# Access Compliance Report

## Public Rights-of-Way

### (Curb Ramps)

Intersection ID: 3683	Main Street: BROMPTON_LN	Cross Street: DAVIS_LAKE_PY	Location: SE
ADA ID: EEB72AA1E49E	Ramp Type: Perp	Initial Pass/Fail: Fail	Overall Compliance: No
			Severity Score: 8.75
Codes/Mitigation Info/Possible Solution		Field Measurements/Component Compliance

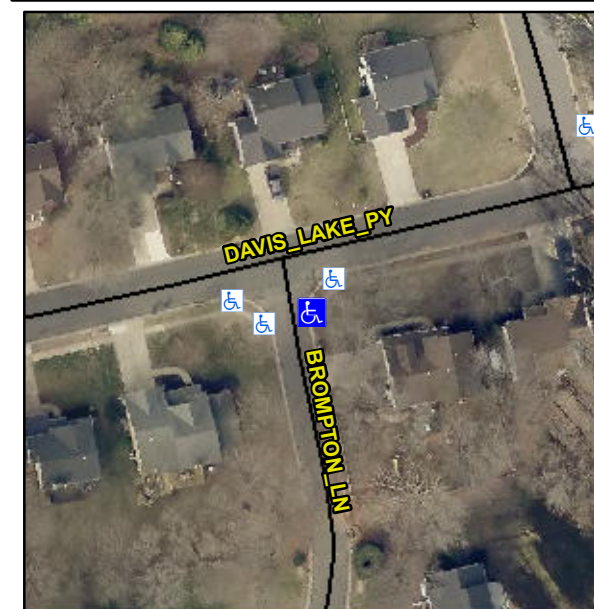
**Not Found, R304.5.1**

Compliance	Description	Data	Compliance	Description	Data
N/A	Ramp Length (in)	52.0	Yes	Ramp Slope (%)	5.6
No	Ramp Width (in)	46.0	Yes	Ramp XSlope (%)	0.7
N/A	Flare Type LT	N/A	N/A	Flare Type RT	N/A
N/A	Flare Slope LT (%)	N/A	N/A	Flare Slope RT (%)	N/A
N/A	Flare Traversable LT?	N/A	N/A	Flare Traversable RT?	N/A
N/A	Landing Length (in)	N/A	N/A	DWS Provided?	N/A
N/A	Landing Width (in)	N/A	N/A	DWS Contrast?	N/A
N/A	Landing Slope (%)	N/A	N/A	DWS Length (in)	N/A
N/A	Landing X Slope (%)	N/A	N/A	DWS Full Width?	N/A
N/A	Landing Curb? (Y/N)	N/A	N/A	DWS Offset (in)	N/A
N/A	Shared Landing?	N/A			
N/A	Gutter Ponding?	N/A	N/A	Gutter Slope (%)	N/A
N/A	Gutter Lip Ht (in)	N/A	N/A	Gutter X Slope (%)	N/A
N/A	Painted X Walk1?	No	N/A	Painted X Walk2?	N/A
	X Walk 1 Direction	To W		X Walk 2 Direction	N/A
N/A	X Walk 1 Width (in)	N/A	N/A	X Walk 2 Width (in)	N/A
	X Walk 1 Slope (%)	2.6		X Walk 2 Slope (%)	N/A
	X Walk 1 X Slope (%)	1.0		X Walk 2 X Slope (%)	N/A

**Remove & Replace Entire Ramp.**
